Project:	New Peebles Elementary School	Project No.:	15041
Prepared by:	Joel Seeley	Meeting Date:	2/15/18
Re:	School Building Committee Meeting	Meeting No:	54
Location:	Veterans Memorial Community Center	Time:	6:30pm
Distribution:	School Building Committee Members, Attendees (MF)

Change Order #1 Summary

# Change Order

# Proposal Request

PR #1 - BWD CHANGES

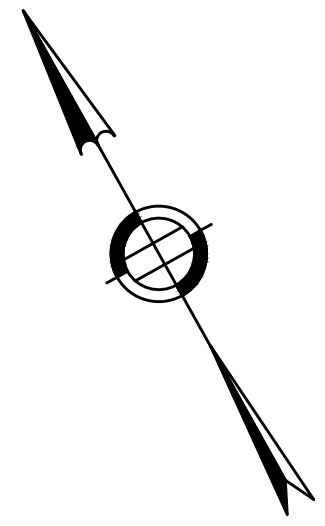
REFERENCE: Specification Section 331000 and sheets C-07 & C-09

Extend the water line at the northwest corner of the building and change pipe materials per the attached sketch and revised specification per request of the Bourne Water District.

ALL FIRE PROTECTION LINES AND APPURTENANCES ARE TO BE INSTALLED PER THE PHASING PLANS. EXCAVATION AND BACKFILL SHALL BE PERFORMED BY THE CONTRACTOR. ALL WATER LINES TO BE PVC EXCEPT AT HYDRANTS WHICH SHALL BE FED BY DUCTILE IRON PIPES.
